TECHNICAL PROCEDURE

TRAILER SUSPENSION SYSTEMS

SUBJECT: CONNEX® ST Stop Bolts

LIT NO: T61003

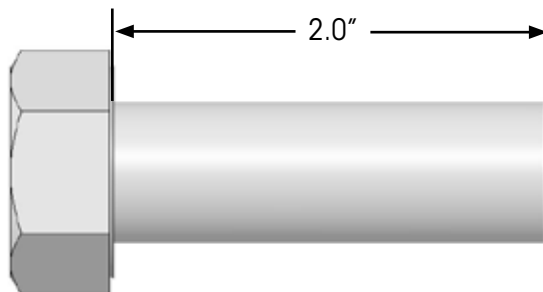
CONNEX ST Self-Steer Suspension Systems manufactured prior to March 2024 use the 2.5 inch stop bolt and after March 2024 use the 2.0 inch stop bolt. Both stop bolts variants are included within the kit and should be used accordingly depending on the CONNEX ST suspension axle end variant that is being serviced with the kit. Refer to T62001 CONNEX® ST Maintenance Procedures for installation instructions.

Prior to March 2024
(Bolt measured from under head to end of threads)

After March 2024
(Bolt measured from under head to end of threads)
